Our ref: 22/04424/PADEV

**RE: PROPOSED LIDL FOODSTORE (CLASS E), WITH ACCESS, PARKING AND LANDSCAPING.**

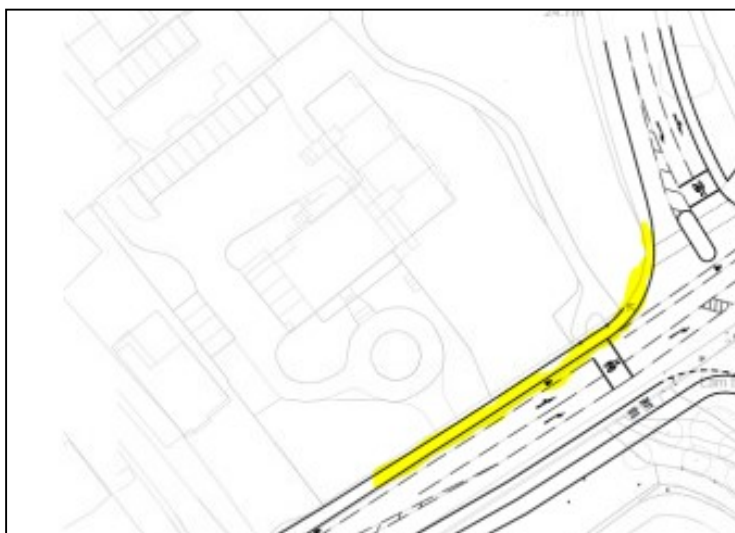
According to EA flood mapping the built area of the site is located partly within Flood Zone 2 and partially within Flood Zone 3 (see picture below).

Regardless of this requirement it is also noted that the access and egress from the site remains via the north west corner which is within flood zone 2 (and possibly zone 3b as above). As such a flood warning and evacuation plan will be required.
